SERVICE BULLETIN

OIL - INTRODUCE AN OIL TANK WITH A REVISED FILLER NECK LOCATION - CATEGORY CODE 7 -
MOD.ENG-79-0014

V2500-ENG-79-0014

Oil tank assembly
Fig.1 (Sheet 1 of 2)

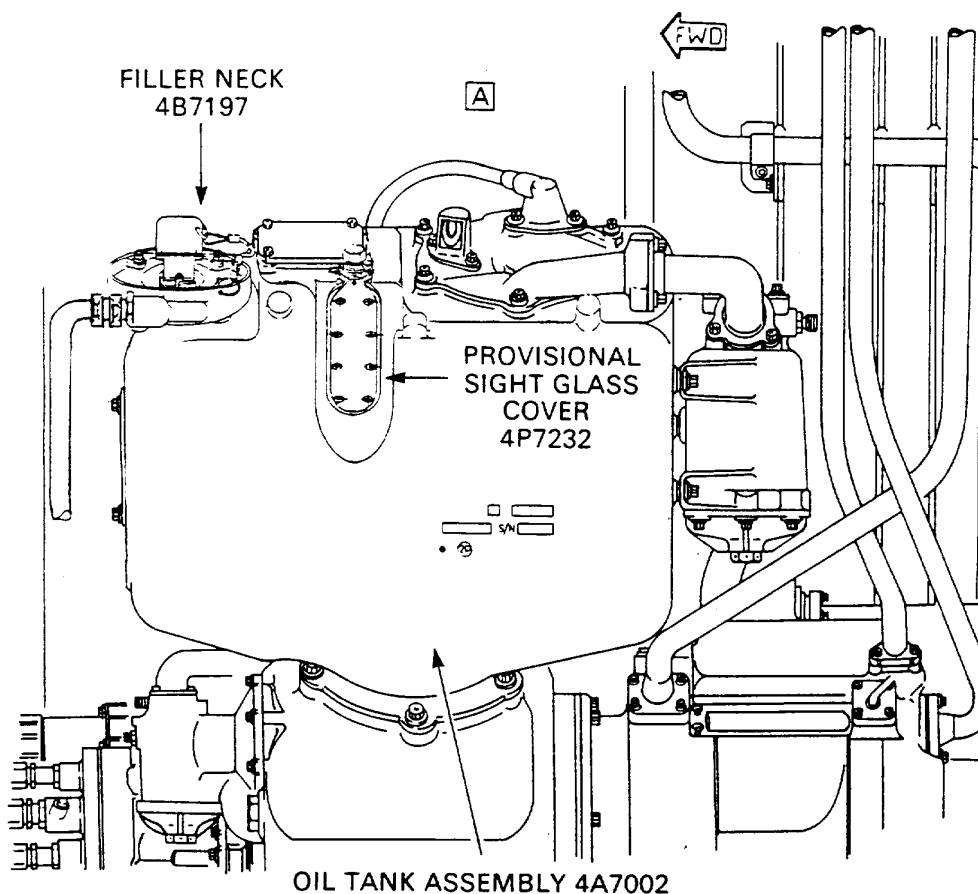
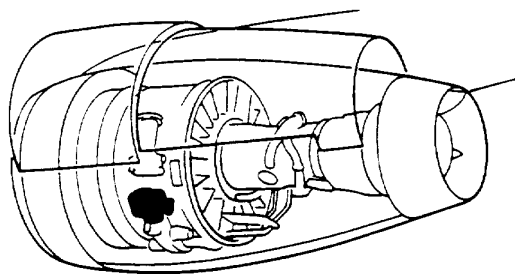
- (1) The oil tank has been redesigned to feature a repositioned filler neck. This will require a revised oil tank scupper drain tube. The redesigned oil tank also accommodates provisions for the incorporation of an oil tank sight glass which will be released on a subsequent service bulletin. In the interim, a cover is fitted at the sight glass location. See Figure 1
